15-DAY COMMENT PERIOD MODIFICATIONS
FOR
PROPOSED BUILDING STANDARDS
OF THE
DIVISION OF THE STATE ARCHITECT ACCESS COMPLIANCE
REGARDING THE FIGURES FOR ACCESSIBLE PARKING OF THE
2007 EDITION OF THE CALIFORNIA BUILDING CODE (CBC)
CALIFORNIA CODE OF REGULATIONS TITLE 24, PART 2, CHAPTER 11B - FIGURES

DSA/AC proposes to update the accessible parking figures to include new language regarding paint stripe color as described in existing Section 1129B.

FIGURE 11B-18A - DOUBLE PARKING STALLS

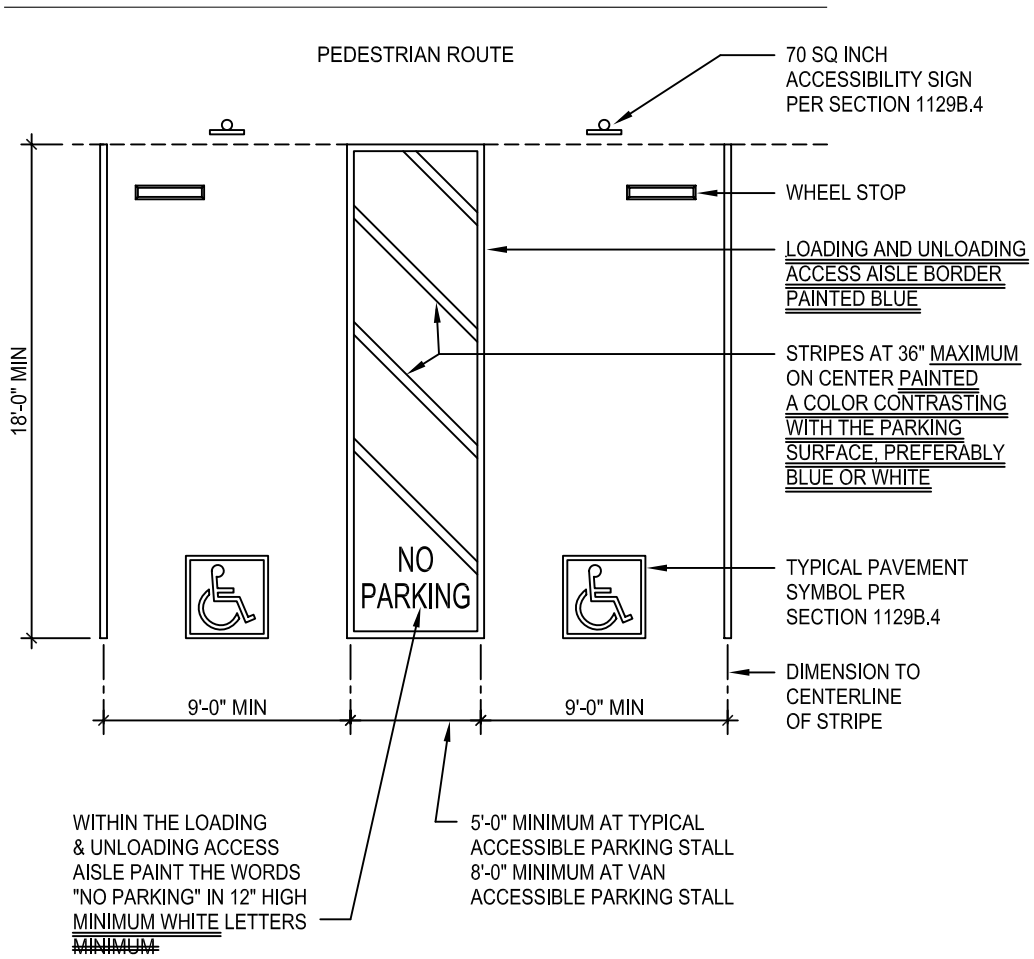
Rationale: Based on a request from Mr. Steven Winkle, who is a member of the California Building Standards Commission, the Division of State Architect – Access Compliance is proposing 15-Day language to add text to the Figures 11B–18A, 18B, and 18C regarding the color of the paint stripping for accessible parking stalls. This will minimize confusion between the figures and written text in Section 1129B.
